Goole Flood Risk

2020 Strategic Flood Risk Assessment – Level II Goole

MIQ Matter 2K – Is the L2 SFRA Robust?

Freedom of Information Request – Robustness of the L2 SFRA Goole

11) Breach Invert Level

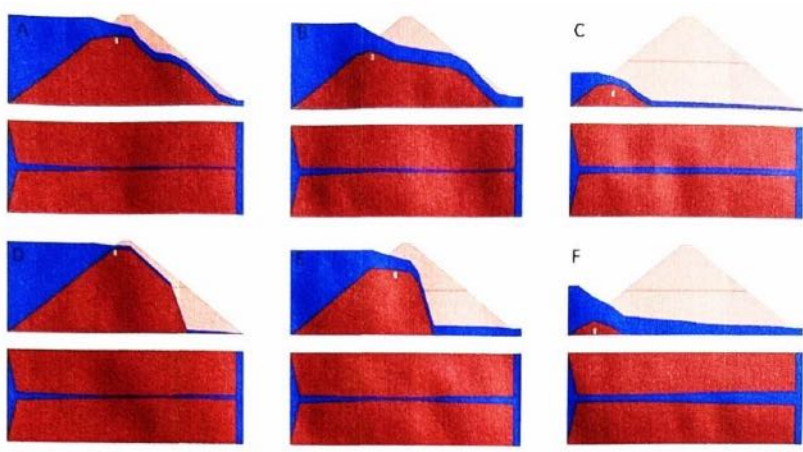
The FOI Dossier reveals that a structural geotechnical survey was recommended to be undertaken, and was planned but for whatever reasons did not occur

The Dossier has not given any robust reason to change from the 2011 L2 SFRA level of 4.6m AOD, i.e. the top of the lower berm

The 2020 L2 SFRA makes prominence of the Rapid Inundation Zone which assumes instantaneous breach. The modelling of an instantaneous loss of the whole lower berm material appears unfeasible, and the 2011 L2 SFRA assumption of loss of the upper embankment appears to be the correct modelling approach.

The change from the 2011 L2 SFRA modelling is not robustly justified in the background data from the 2020 L2 SFRA taking into account the more recent 2023 H.R Wallingford publication, and further the lack of any site assessment of the embankment does not give justification to a change in the breach invert level.

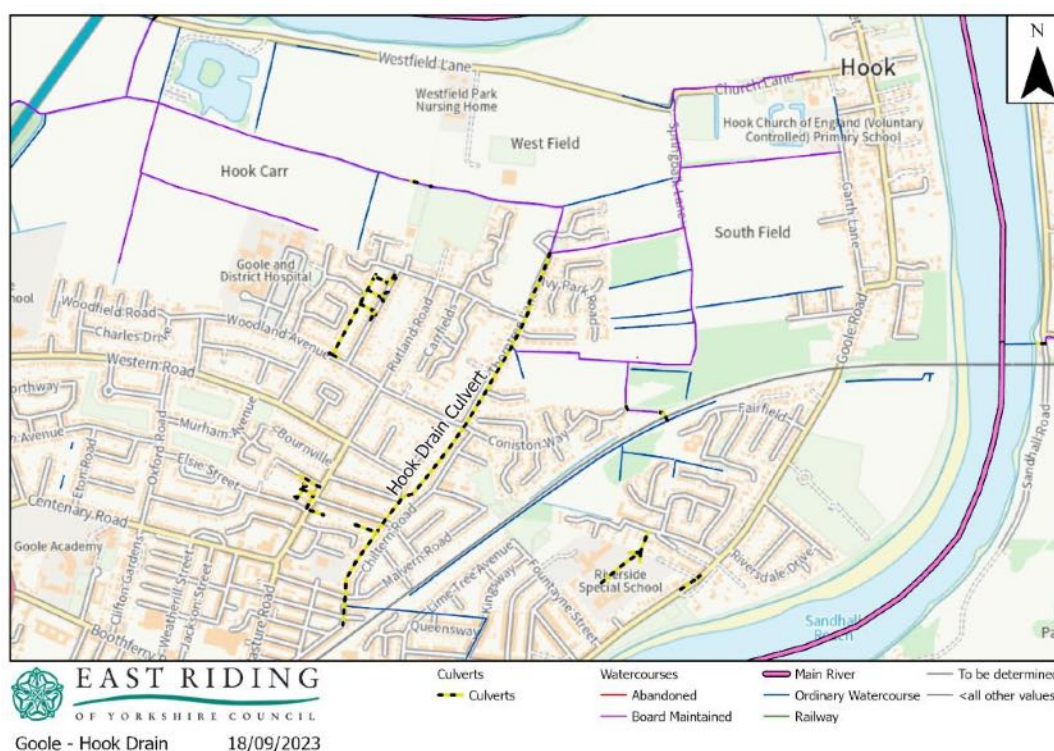
“Hook Drain is a major riparian watercourse serving Goole. It consists of an open channel section discharging north to Hook Clough pumping station and a culverted section along Long Lane and Thontree Lane which drains to the open channel via a flapped outfall. It also discharges south into the North Street trunk sewer and from there to Lock Hill pumping station”

**This is challenged as the culverted sections (which have been lost over the years by new residential developments) including the connection from the railway line to North Street
Could the ERYC provide mapping/survey details which support this 2020 SFRA statement?**

Please see the attached map, which details our currently held records of the drainage system described in the query. Our records are based on the best available data at the time.

Our records indicate that the culverted system is still active presently and has not been removed. This is supported by Yorkshire Water's records, which also indicate that the connection across the railway line is still active, however we cannot share Yorkshire Water's records due to the limitations of our data sharing agreement. Yorkshire Water may be able to provide more details of their sewer network.

Figure 5-1 - Goole – Modelled breach locations, numbering in accordance with Upper Humber 2016 study.

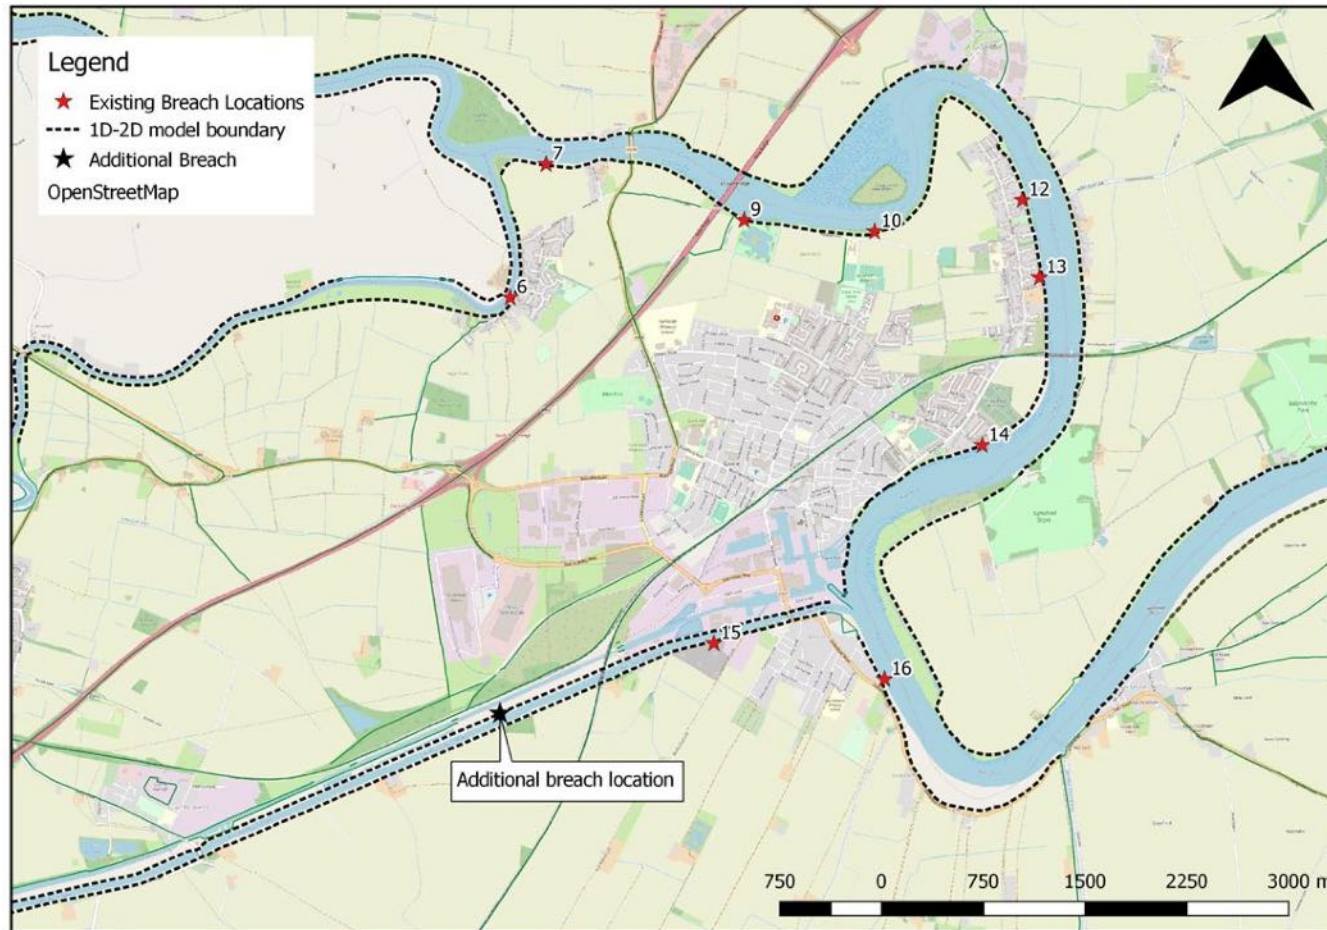
<ul style="list-style-type: none"> Please confirm location of new breach location (or options being considered) on Dutch River / River Don. 	<p>No Action: This is clearly shown in Figure 5.1 of the version 2 approach note.</p>
<ul style="list-style-type: none"> For Goole, the breach scenarios should be combined with the local gate failure scenarios such that the slightly higher ground near the docks is included in the overall residual risk picture. Please see screenshot in the "model boundary and setup" excel attachment (cell A26) for areas where this applies. We can supply the data if you haven't already got these. No climate change scenarios are available. 	<p>Decision: ERYC to decide whether they want to consider two further breaches at each of the docks are shown at risk rather than out of flood risk.</p>
<p>Hedon:</p>	
<ul style="list-style-type: none"> For Hedon, for the downstream estuary condition, it suggests Paull Village is used rather than Saltend (Paull is 30mm higher). Is there a reason for this? It is possible this difference is insignificant. Tab added to spreadsheet with Saltend levels. 	<p>No Action: Paull was selected as part of Burstwick Estuary is represented in the model. Paull, we have picked the node in the middle, as alluded to by Andrew the difference is a conservative number.</p>

- Please confirm location of new breach location (or options being considered) on Dutch River / River Don.
- For Goole, the breach scenarios should be combined with the local gate failure scenarios such that the slightly higher ground near the docks is included in the overall residual risk picture. Please see screenshot in the "model boundary and setup" excel attachment (cell A26) for areas where this applies. We can supply the data if you haven't already got these. No climate change scenarios are available.

Figure 1 – “contouring” to interpolate hazard between breach locations – taken from previous L2 SFRA.

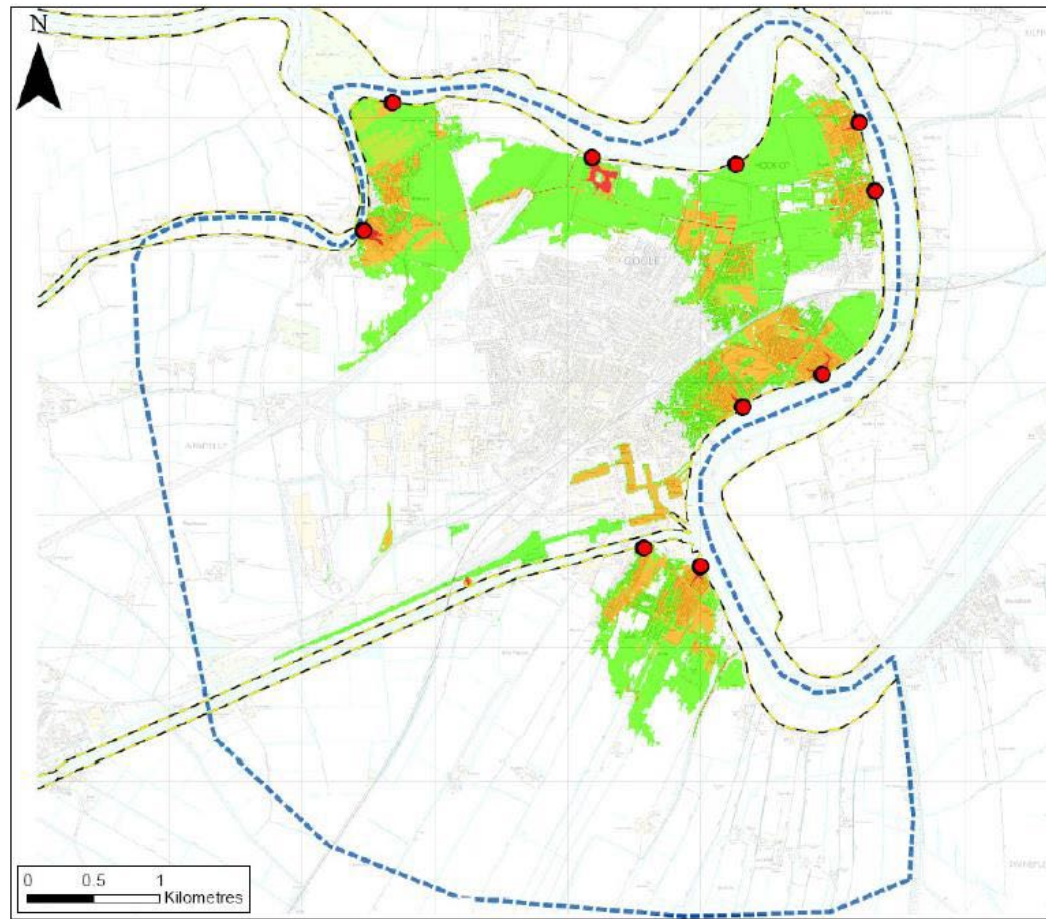
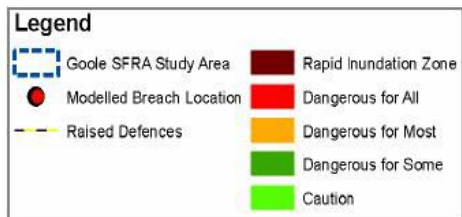
RECOMMENDATION 1.03 – Areas that lie between individual breaches appear to be at lower flood risk than those immediately behind other parts of the defence. In reality, a breach could occur anywhere. We would recommend a “contouring” of the hazard zones near the flood defences, similar to what was done with the previous 2012 Level 2 SFRA (see Figure 1). The contouring exercise would also help to remove anomalous areas, for example, those behind defences, which appear in lower hazard categories than might be expected. Alternatively, you could re-introduce a notional distance for the RIZ, as per the previous L2 SFRA.

Figure 2 – Goole dock failure extents

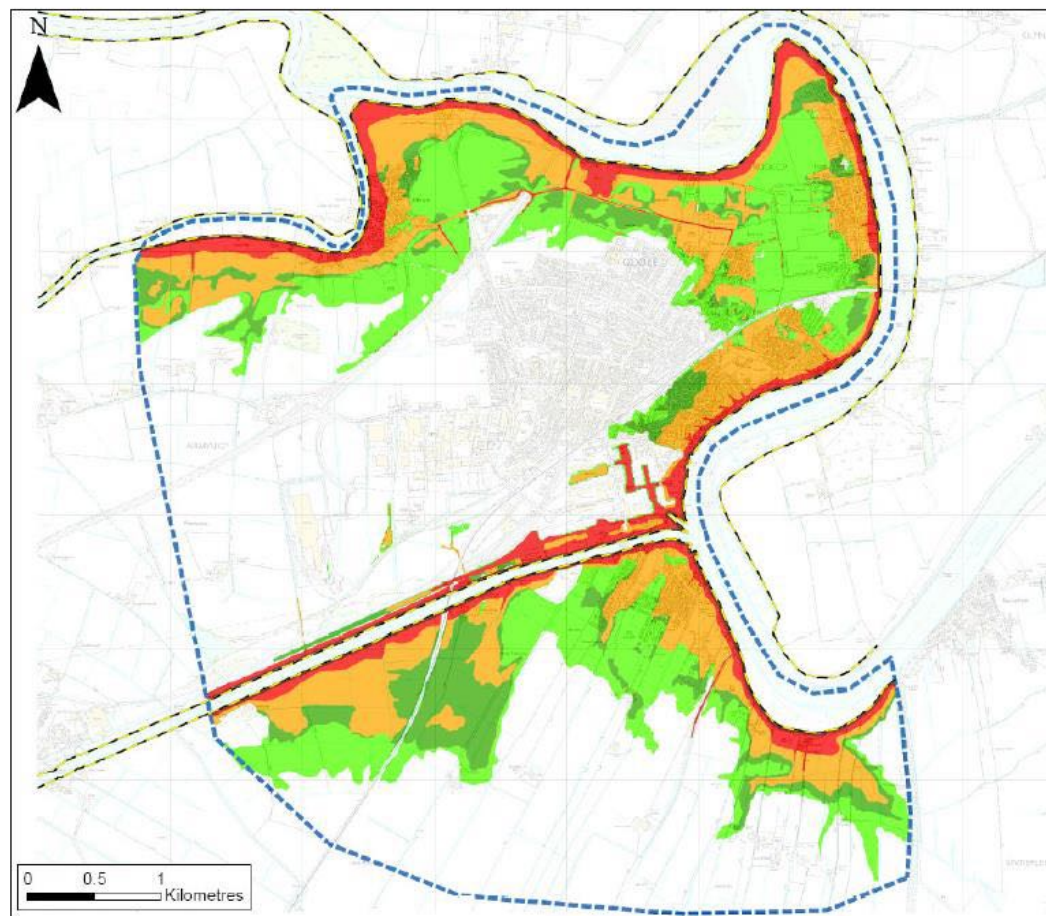
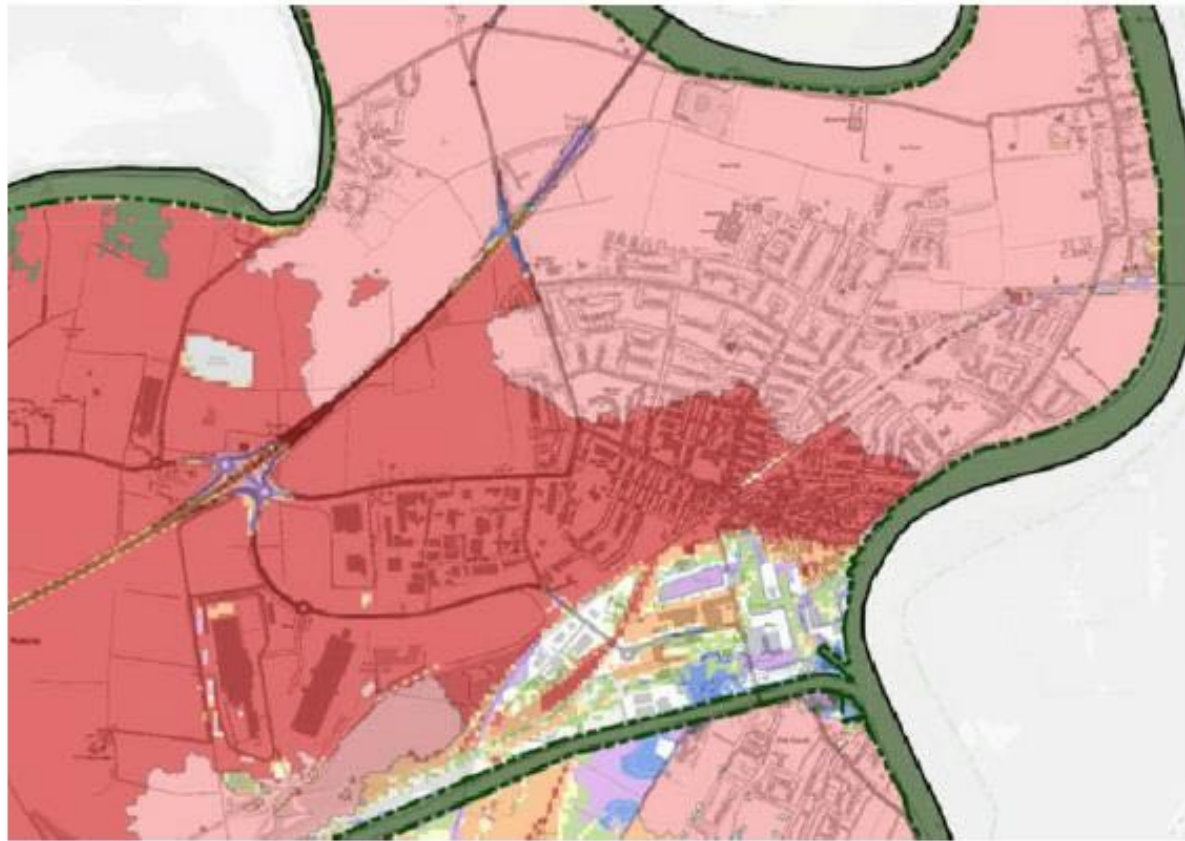
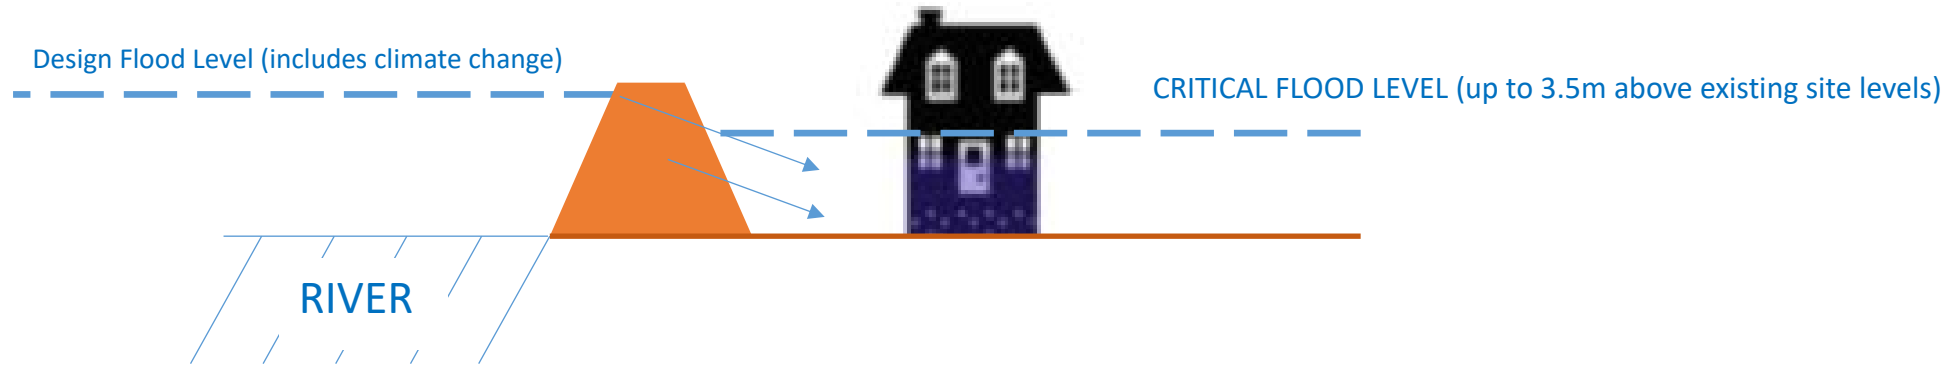
RECOMMENDATION 3.01 – Use the Environment Agency modelled failure of dock infrastructure at Victoria and Ocean Docks. In the event the gates fail, a large part of the town would flood, including areas that, on the basis of Appendix E, would currently appear to be at lower flood risk. The simulations modelled by the Environment Agency follow the parameters used for breaching. The results show increased risk to parts of the town around the docks, and may influence the location, scale and design of developments coming forward in those areas (see Figure 2).
